DATE: DECEMBER 8, 2011

TITLE: PELICAN™ REDESIGNS THE 9430 REMOTE AREA LIGHTING SYSTEM (RALS)

PRODUCTS AFFECTED: PELICAN 9430 REMOTE AREA LIGHTING SYSTEM (RALS)

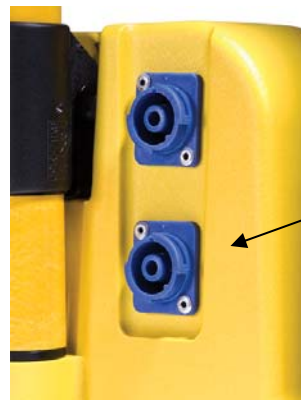
- Added more efficient LEDs:

- **New array - 6 LEDs**
- **Same lumen output:**
  - 2,000 in High
  - 1,000 in Low
- **Same run time:**
  - 8 hours in High
  - 15 hours in Low

- Original array - 24 LEDs
- Lumen output:
    - 2,000 in High
    - 1,000 in Low
  - Run time:
    - 8 hours in High
    - 15 hours in Low
